# Work Order ID 88435

Item Name: Crosstube Fwd High

<b>DART AEROSPACE LTD</b>	<b>Work Order:</b>	88435
<b>Description:</b> Crosstube High Fwd (205/212/412)	<b>Part Number:</b>	D212-664-101
<b>Inspection Dwg:</b> D212-664-141 <b>Rev:</b> D		<b>Page 1 of 1</b>

DRAWING NO. D212-664-141	TITLE XTUBE ASSY (205/212/412 HI FWD)	REV. D	<b>DART AEROSPACE LTD ENGINEERING ORDER</b>		D.E.O. NO. D212-664-141-D-1	SHEET NO. SHEET 1 OF 2	SCALE NTS
DRAWN	CHECKED	<i>UP</i>	MFG. APPR.	<i>ER</i>	APPROVED	<i>MAP</i>	DE APPR.
DATE 11.04.07	DATE 11.07.11		DATE 11.04.12		DATE 11/04/12		DATE 11.04.12

**D212-664-141/-141B  
ASSEMBLY DETAIL**

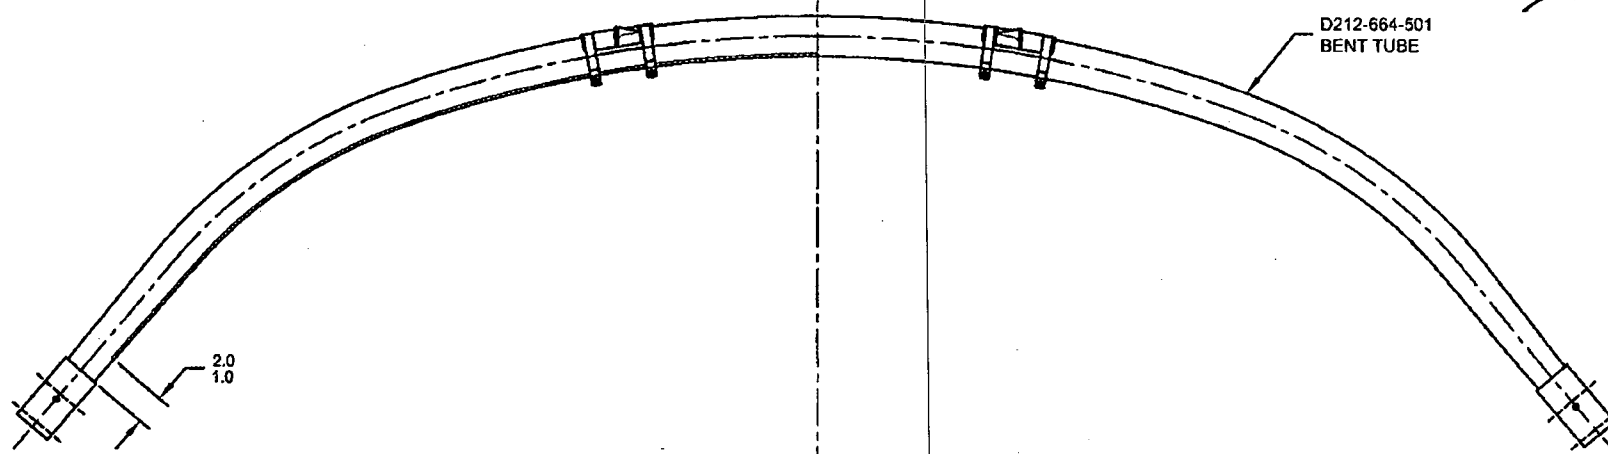
ADD AN INSPECTION WINDOW TO UNDERSIDE OF CROSSTUBE.

NOTES 2 OF SHEET 1 IS AMENDED AS FOLLOWS:

- 2) FINISH: CHEMICAL CONVERSION COAT PER DART QSI 005 4.1  
PRIME INSIDE AND OUTSIDE PER DART QSI 005 4.2  
MASK UNDERSIDE OF CROSSTUBE AS SHOWN (HATCHED AREA) AND  
PAINT OUTSIDE PER DART QSI 005 4.2  
REMOVE MASKING AND APPLY CLEAR COAT

MASK AREA PRIOR TO PAINTING,  
REMOVE MASKING AFTER PAINT  
AND APPLY CLEAR COAT
